MONTGOMERY COUNTY HISTORIC PRESERVATION COMMISSION STAFF REPORT

Address: 23515 Frederick Road to Meeting Date: 10/28/2020

Review: HAWP Staff: Michael Kyne

PROPOSAL: Construction of shared-use path with associated hardscape, lighting, grading, tree

23421 Frederick Road

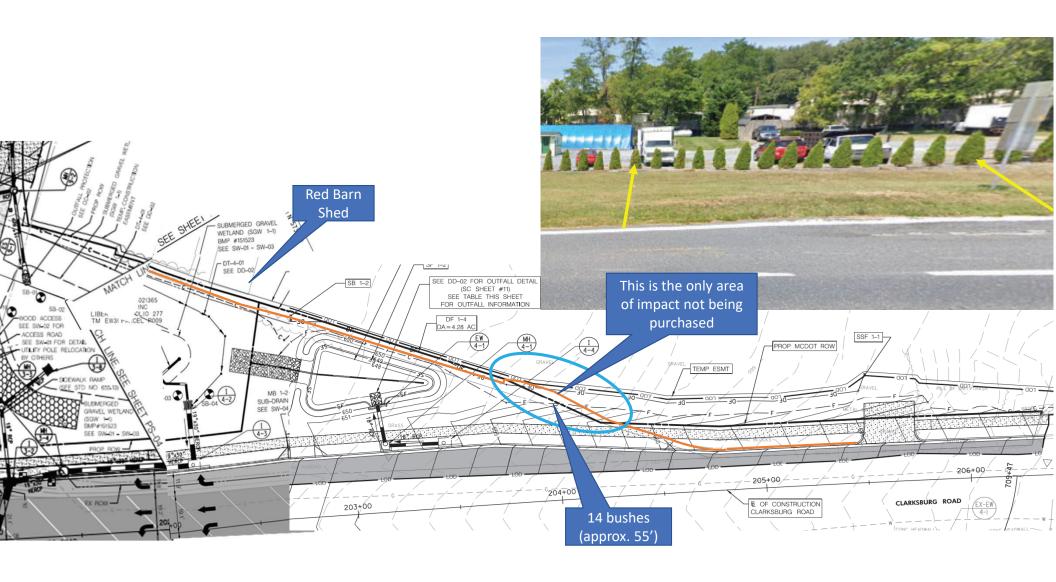
Our property Acquisition Specialist contacted the property owners on 6/1, 9/18, and 9/24. The property owner has now hired a lawyer to represent him.

- Reduced the driveway entrance width from 30 to 20 foot
